# DART SERVICE INSTRUCTION

TO AMEND INSTALLATION INSTRUCTIONS IIN-D412-702-1 REV. A OR EARLIER APPROVED REVISION AND INSTRUCTIONS FOR CONTINUED AIRWORTHINESS ICA-D412-702 REV. 4 OR EARLIER APPROVED REVISION

THE PURPOSE OF THIS DSI IS TO PROVIDE AN OPTION FOR INSTALLATION OF THE D3215-041 (-011/-017 KITS) HARNESS ASSEMBLY OR D3446-041 (-021/-027 KITS) HARNESS ASSEMBLY TO ACCOMODATE SMALLER PASSENGERS.

**FIGURE 1: ALTERNATE POSITION FOR D3215-041/D3446-041 HARNESS ASSEMBLIES**

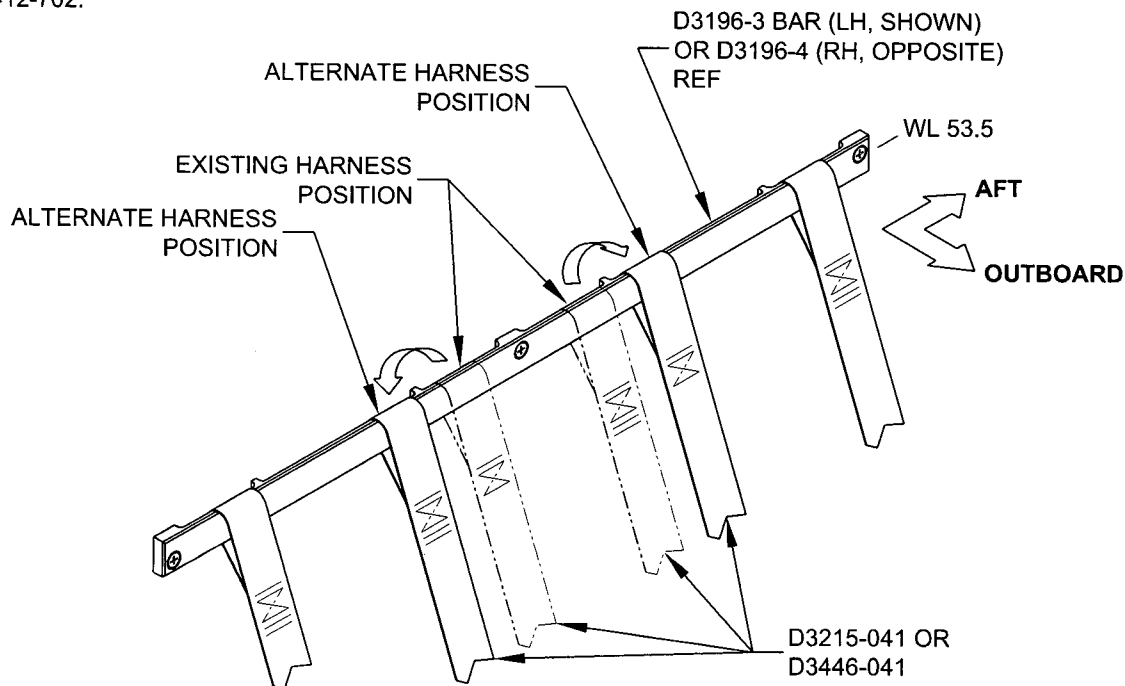
FIGURE 1 BELOW PROVIDES AN ACCEPTABLE ALTERNATIVE TO FIGURE 3.7 OF IIN-D412-702-1 OR FIGURE 25.7 OF ICA-D412-702. THE CENTER STRAPS CAN BE RELOCATED TO THE LARGER SLOTS AS SHOWN IN FIGURE 1 OF THIS SERVICE INSTRUCTION. THE INSTALLATION OF THE HARNESS ASSEMBLIES SHOULD BE COMPLETED BY INSTALLING THE D3551-11 HOOK AND LOOP TIE IN ACCORDANCE WITH FIGURE 3.4 OF IIN-D412-702-1 OR FIGURE 25.4 OF ICA-D412-702.
